NAME	DATE	<b>PREMAC</b>			
DRAWN	Dan	07/27/10				
APPROVED			TITLE			
MATERIAL						
TREATMENT			UNLESS OTHERWISE SPECIFIED DIMENSIONS ARE IN MILLIMETERS			
			1 <sup>st</sup> ANGLE	SIZE A4	DWG NO	REV
			2 PL ±0.02 3 PL ±0.005	FILE NAME: Out Rigger Block Mod.dft		
				SCALE:	WEIGHT:	SHEET 1 OF 2

SECTION A-A

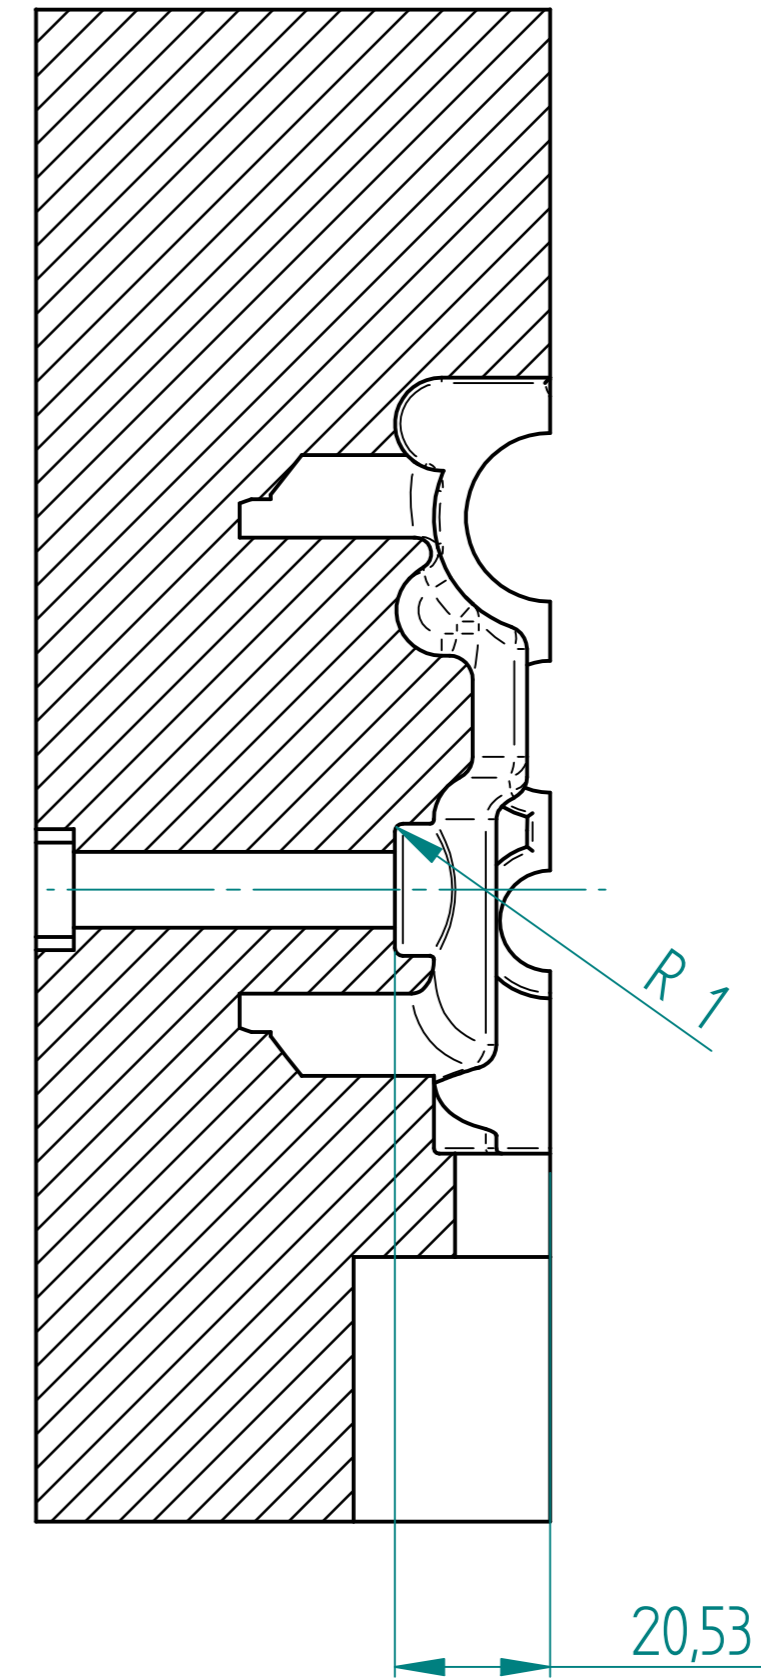
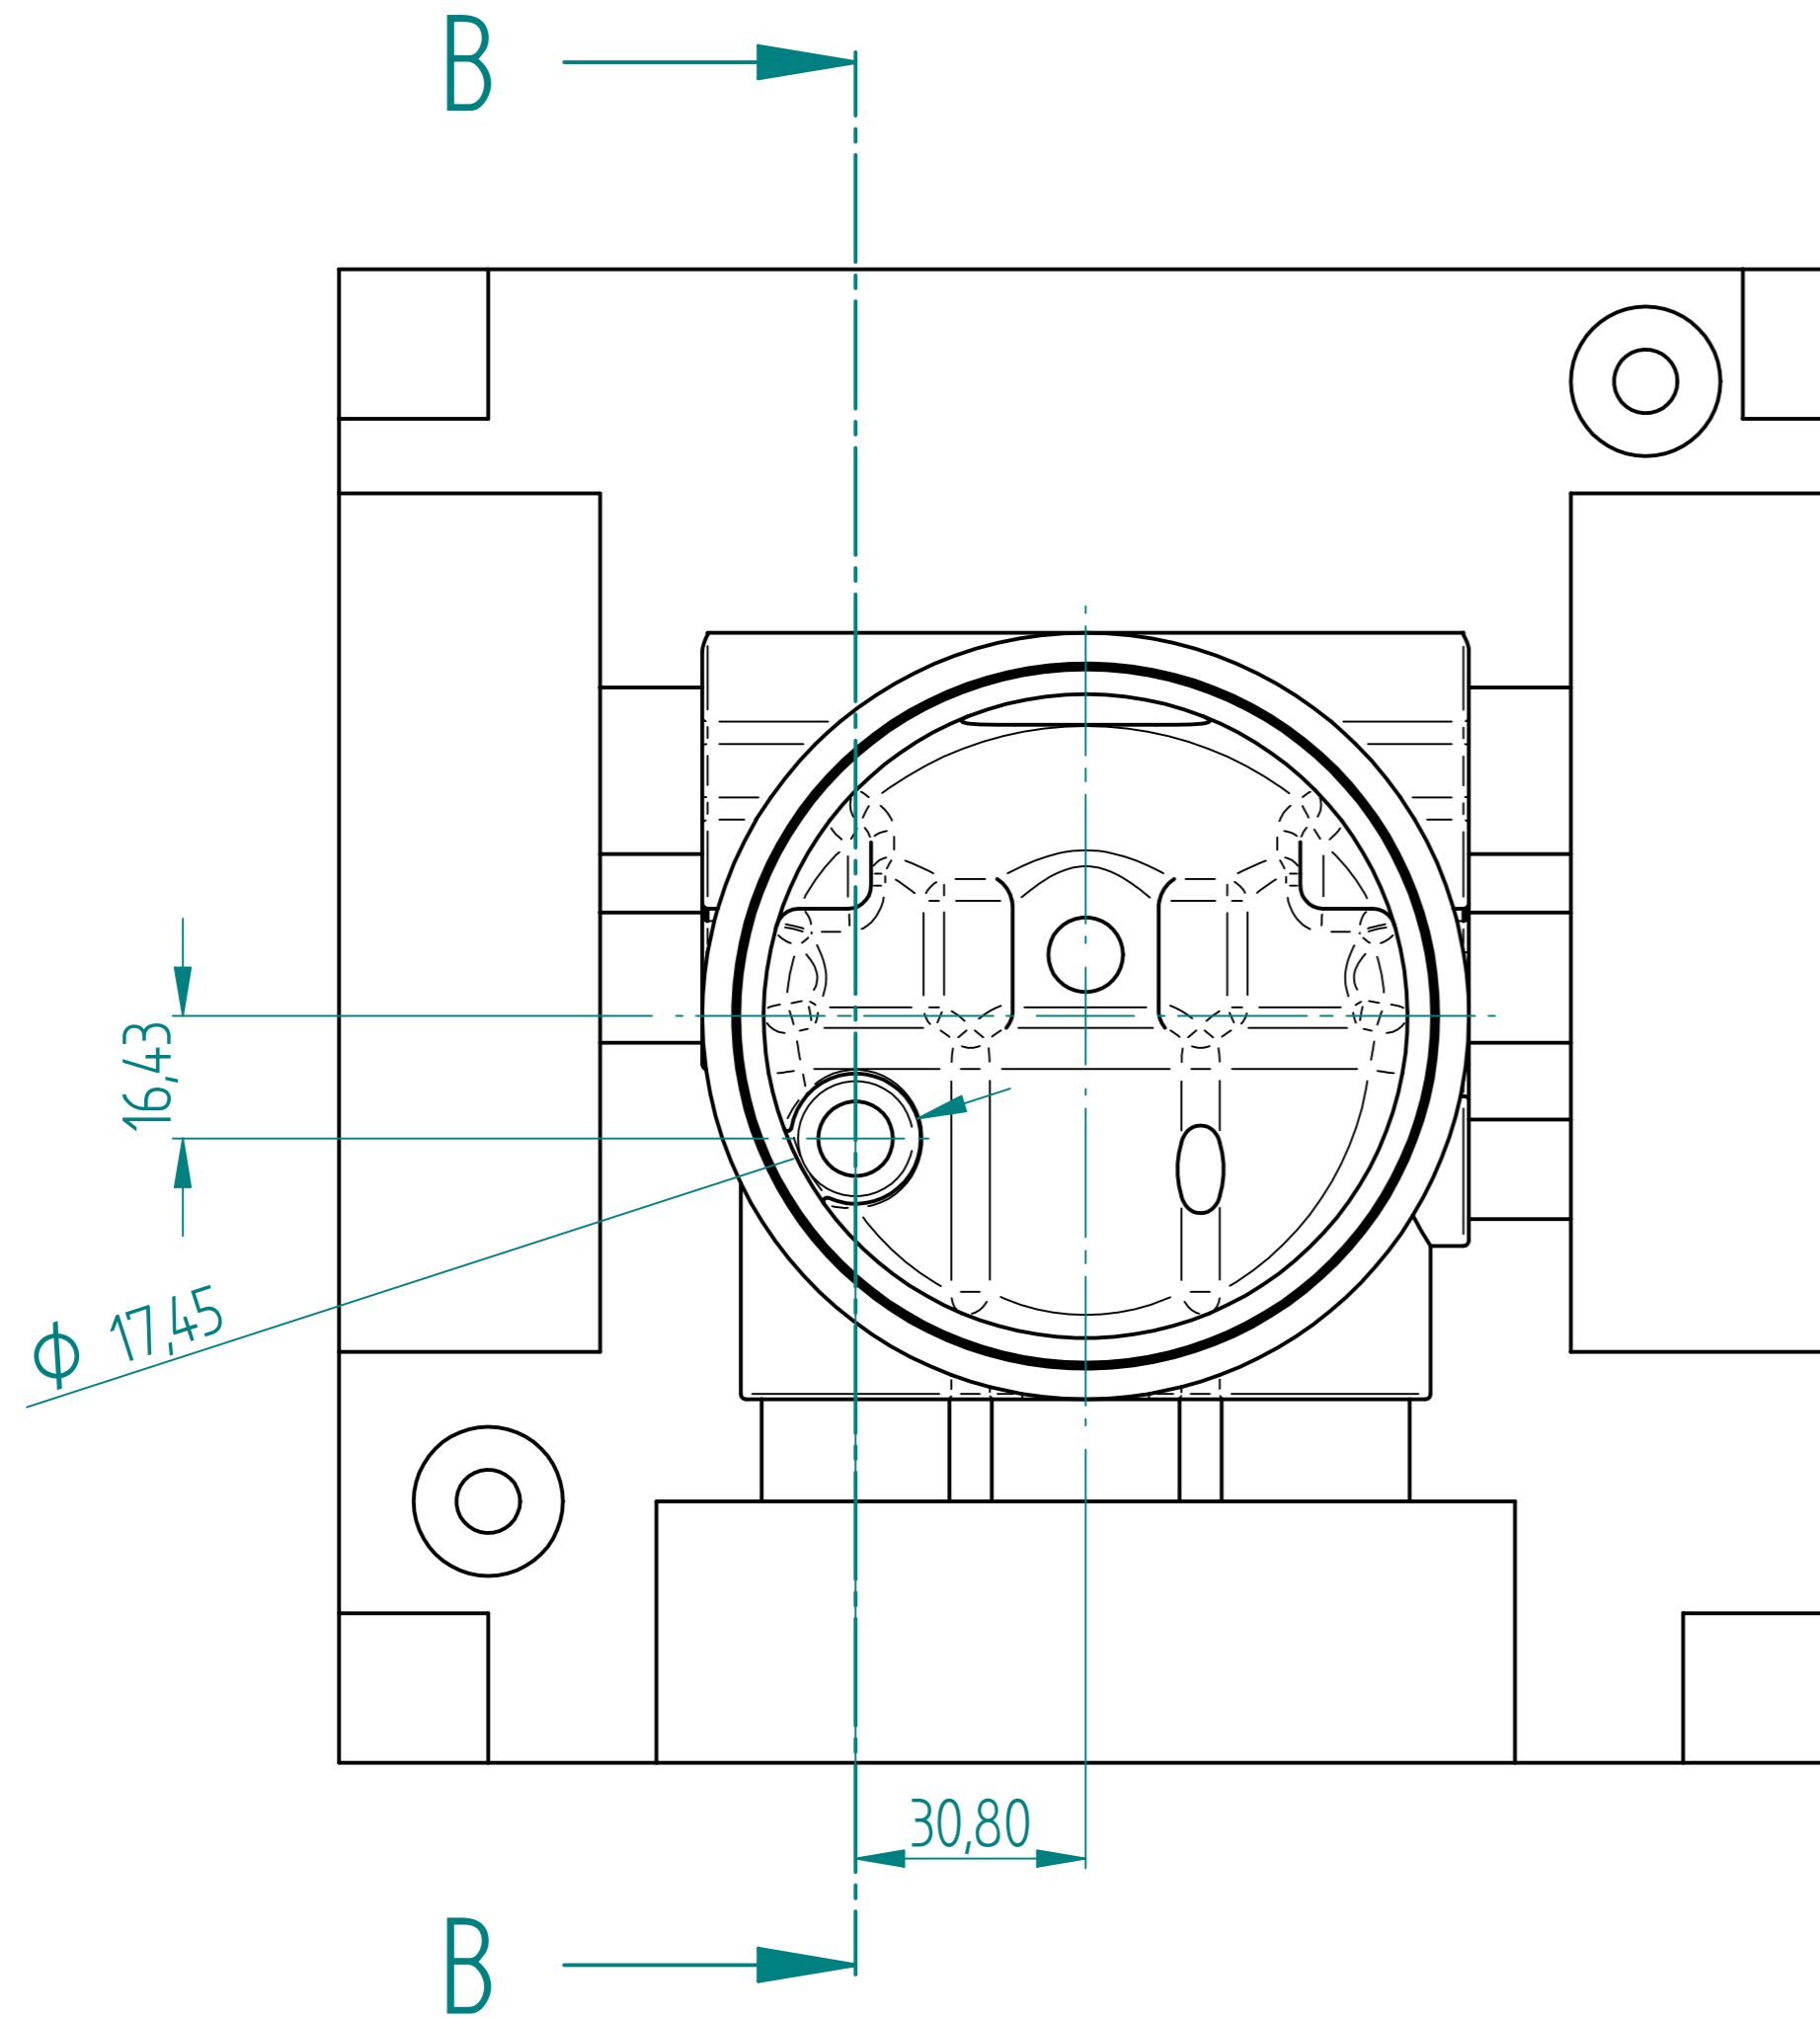
A BOSS OF DIA 17.mm AND MAINTAINING THE THROUGH HOLE OF DIA 10.mm NEEDS TO BE ADDED TO THE BLOCK AT THE POSITION INDICATED ON THE WAX MOULD DIE PLATE.
